2025 GROUP B PROPOSED CHANGES TO THE I-CODES

April 27 – May 6, 2025
Doubletree by Hilton
Universal Orlando - Orlando, FL

Publication Date: March 2025

FIGURE R802.7.1-2 R802.7.2.2 CEILING JOIST TAPER CUT

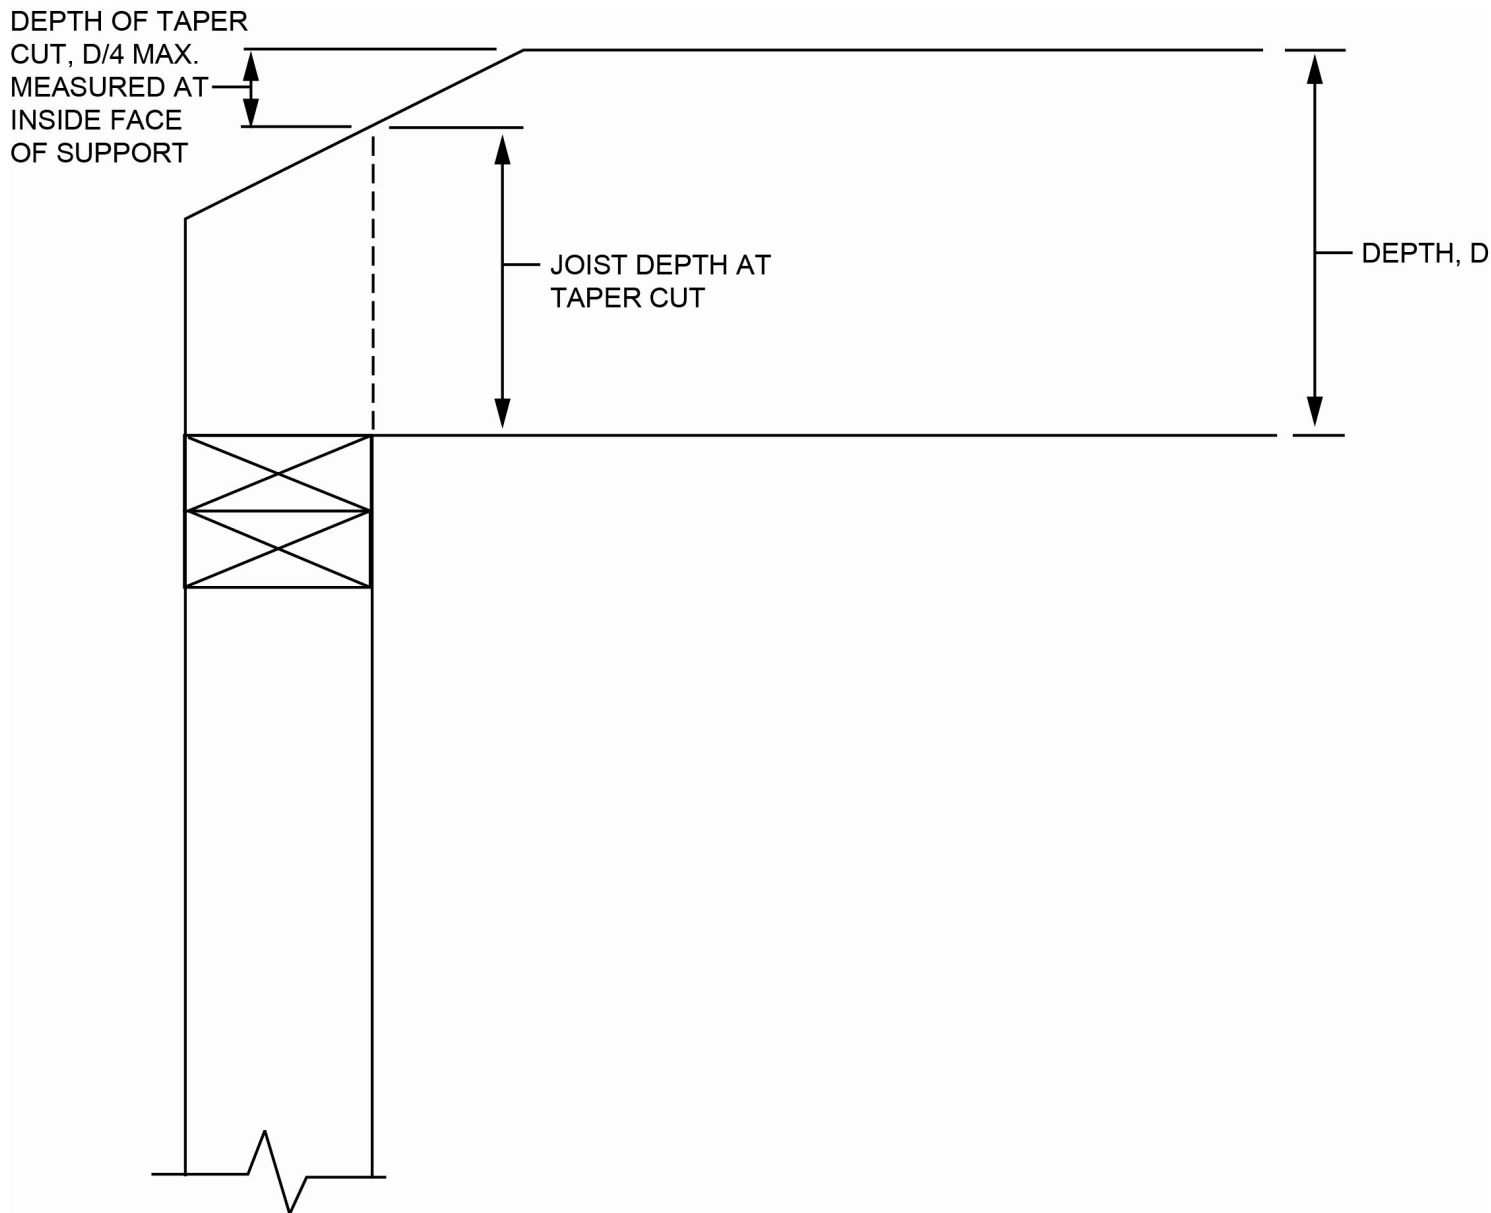
Exception: Where the entire side of the wall with the notch or cut is covered by *wood structural panel* sheathing.

FIGURE R507.9.1.3(2) R507.8.3(2) PLACEMENT OF LAG SCREWS AND BOLTS IN BAND JOISTS

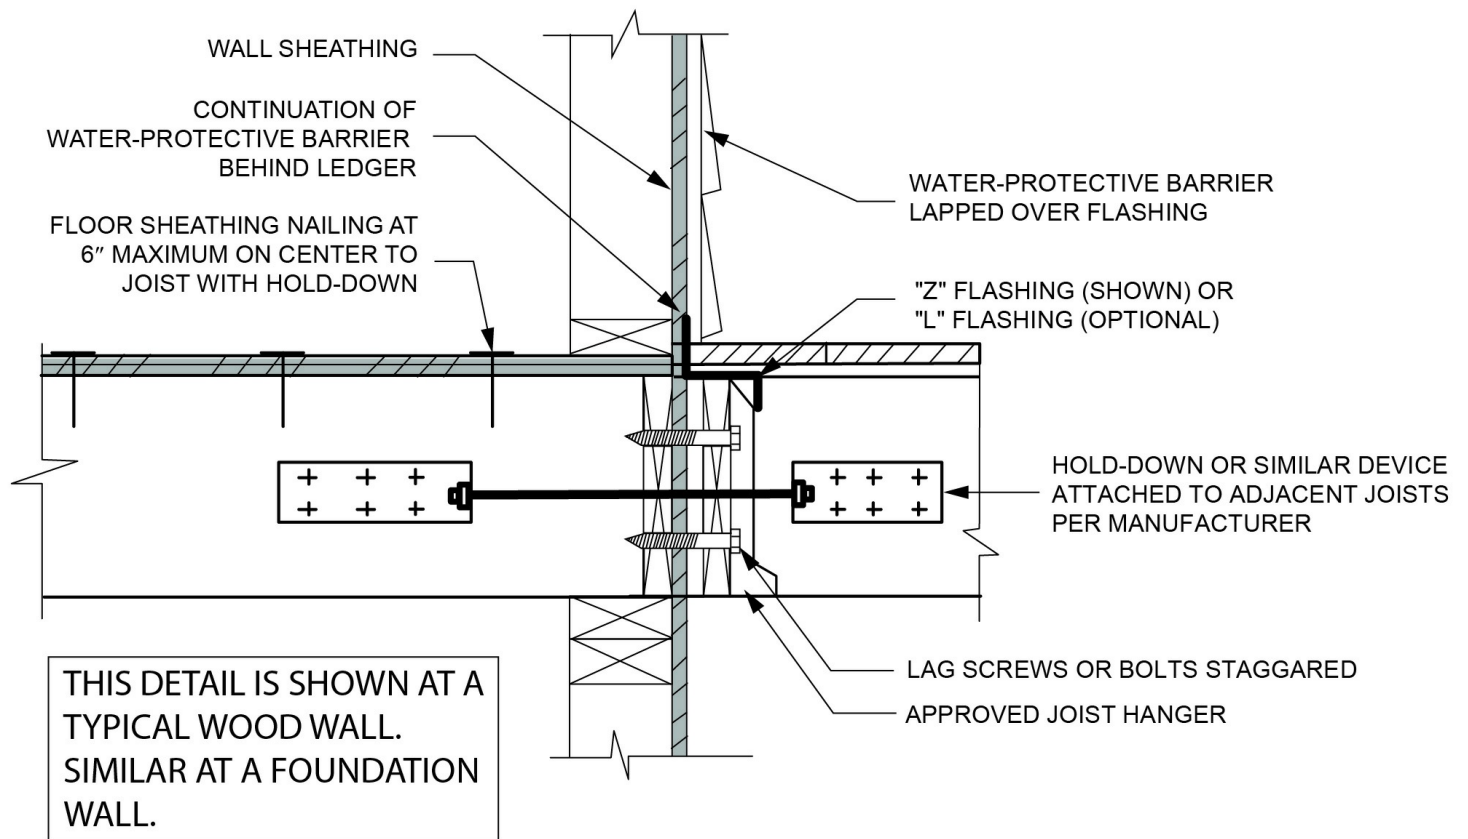
- b. Maximum 5 inches.
- c. For engineered rim joists, the manufacturer's recommendations shall govern.
- d. The minimum distance from bottom row of lag screws or bolts to the top edge of the ledger shall be in accordance with Figure R507.9.1.3(1).

FIGURE R507.9.2(1) DECK ATTACHMENT FOR LATERAL LOADS

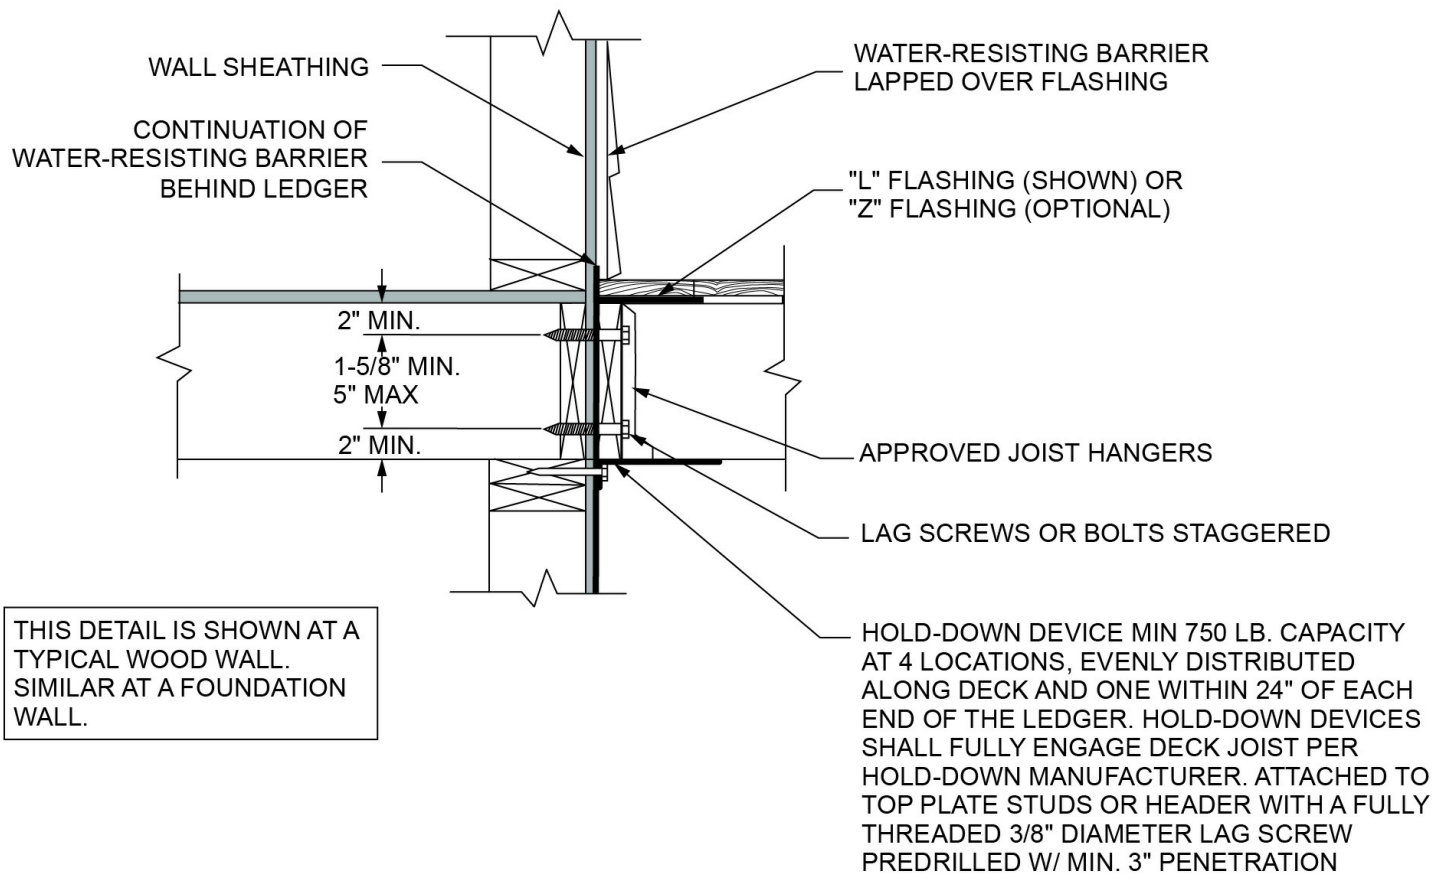
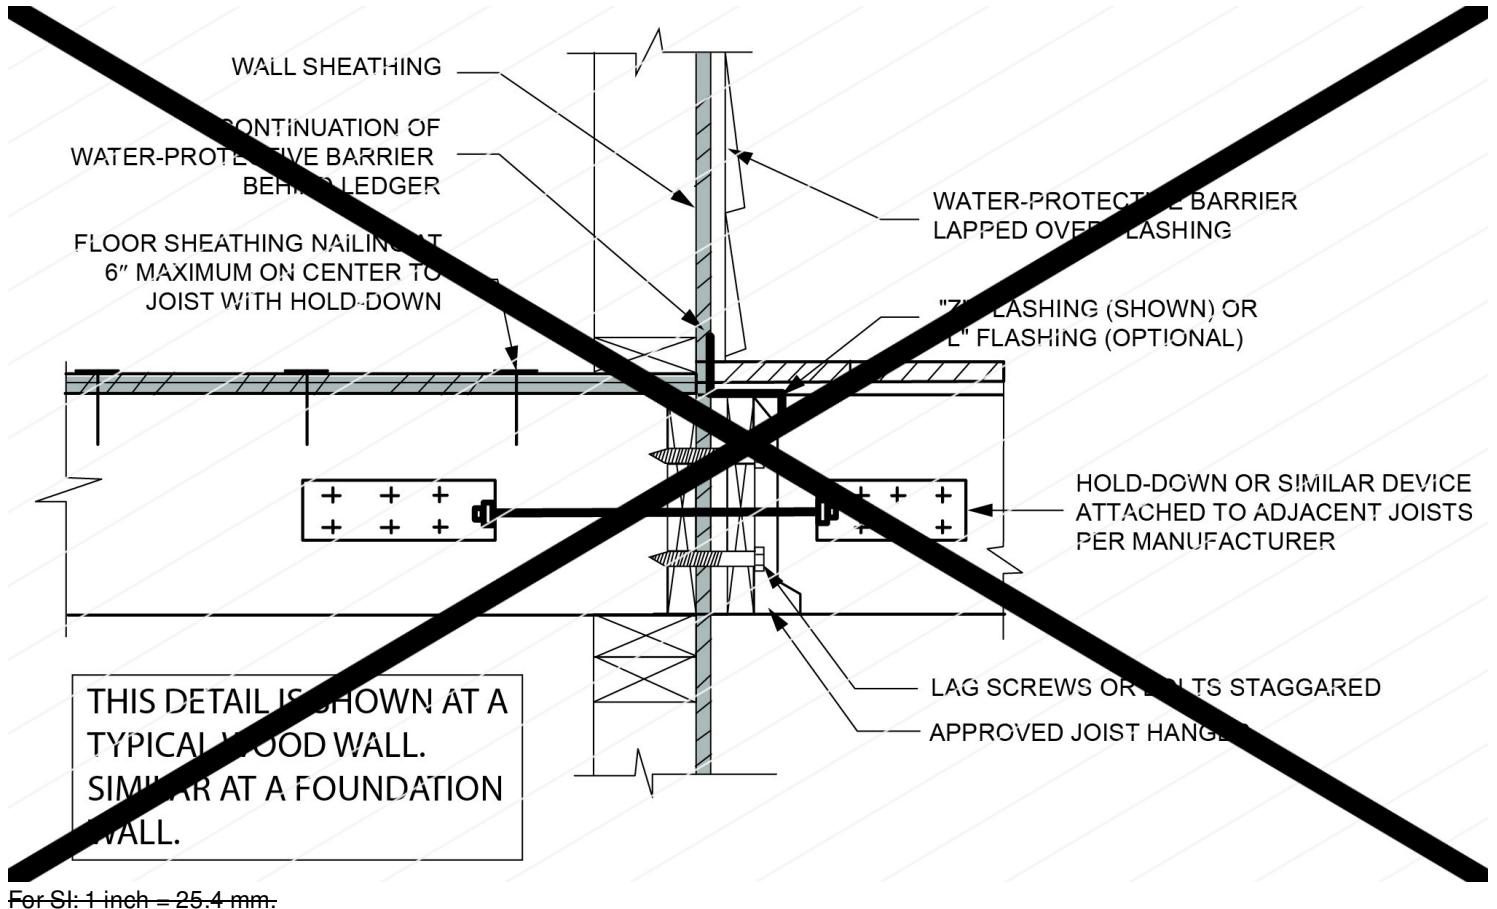
Delete and substitute as follows:
